## PROJECT ANATOMY

DOCUMENT CONTROL			
DOCUMENT TITLE	AIR QUALITY TECHNICAL NOTE	REVISION	R00
DOCUMENT NUMBER	103575	ISSUE DATE	28 <sup>TH</sup> JANUARY 2021
PROJECT NAME	PROJECT ANATOMY	AUTHOR	SG
STATUS	ISSUE	CHECKED	DS
ISSUED TO	CLIENT	PASSED	SG

- 1.1. This Technical Note (TN) has been prepared by Vanguardia in response to comments raised by the London Borough of Camden in respect to an Air Quality Assessment, undertaken by Vanguardia (ref: Project Anatomy – Air Quality Assessment dated August 2021) submitted in support of the planning application (ref: 2021/3673/P) for a:

## FUME EXHAUST FLUE STACK HEIGHT TECHNICAL SUMMARY

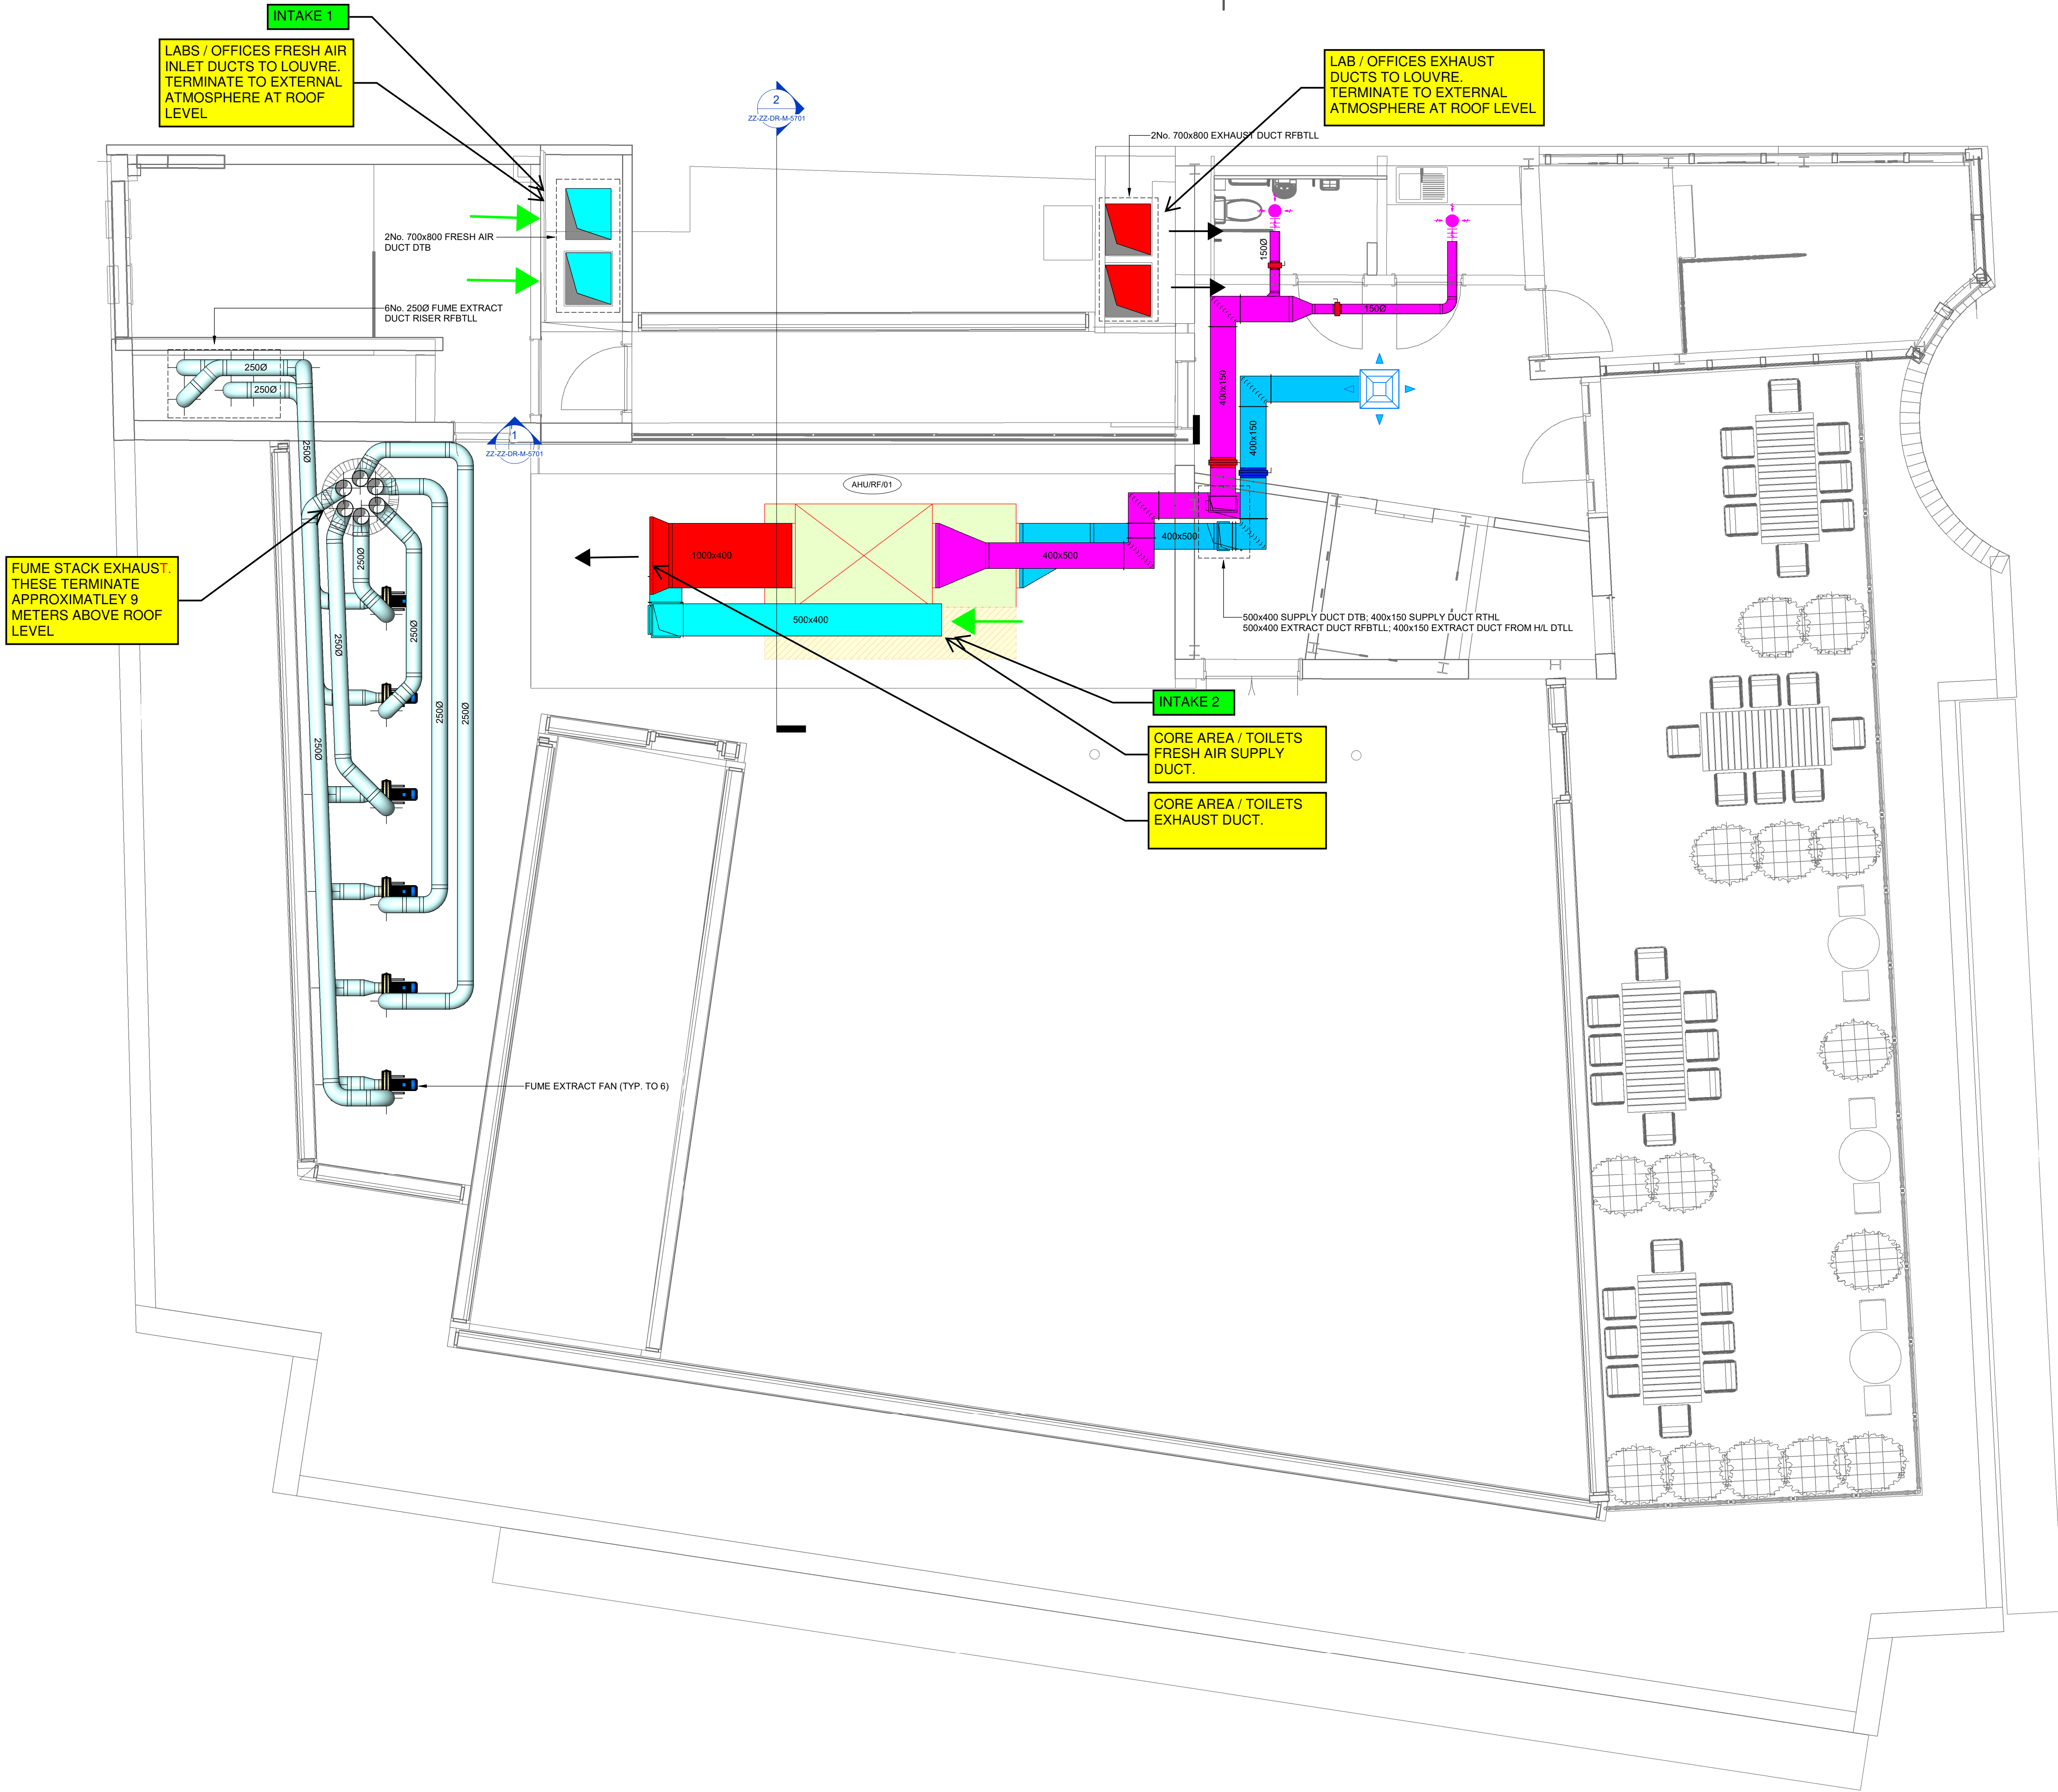
***It is not clear from the information provided how far above the top of the building the top of the flue is (1.2 refers to 9m and table 5 refers to 27.7m), the prevailing wind direction (particularly in relation to the roof terrace), and exactly what the fumes may contain. Figure 2 does not show both flues indicated on Figure 6. Therefore it is not possible to determine if the proposals are sufficient to protect the amenity of residents in accordance with London Borough of Camden Local Plan Policy CC4 and London Plan policy SI 1. In particular the location of the roof terrace in close proximity to the Flue shown in figure 2 and unknown location of the fresh air inlets for the building are a concern. As a result further information is required.***

**The location of the fresh air intakes has not been specified and the minimum required distance has not been set out. As a result further information is required**

- 1.3. The exit point of the stack (z height) has been taken from the application drawing of, and is 27.7m (minus ground floor level). For individual flues exhausting 1 no. fume cupboard per floor,

the currently designed 9m height is a good starting point at this stage – Therefore stack height is 9m above the roof line has been used in the assessment. KJ Tait Engineers have provided the appended TN (ref: *Fume Exhaust Flue Stack Height Technical Summary*) which sets out the site constraints, and concludes:

- 1.8. We have been informed where the air intakes on the roof are located, and this information has been appended to this TN, and discussed further in the *Operational impact on occupants* comments below.

- 1.16. We can further consider the potential  $\text{PM}_{10}$  and  $\text{PM}_{2.5}$  concentrations at the air inlet locations on the roof line (drawing is appended to this TN). The first method would be to undertake

- 1.20. The proposed inlet locations are set out in the appended drawing. It is recommended that the monitoring approach / mitigation above would cover this comment (via planning condition).

The flue stack is therefore proposed to be located to the West side of the 85 Gray's Inn Road roof, i.e. the farthest point from the ITN building. This location also benefits from less influence on the plume dispersal by rooftop recirculation for the prevailing west and south westerly winds.

The flue stack height will have less influence on the ITN Building, however it will have an impact on the dispersion levels achieved at the proposed air intakes and the rooftop terrace area on 85 Gray's Inn Road. The RWDI analysis identified that the original proposed 9m flue height can be reduced to 8m above the roof.
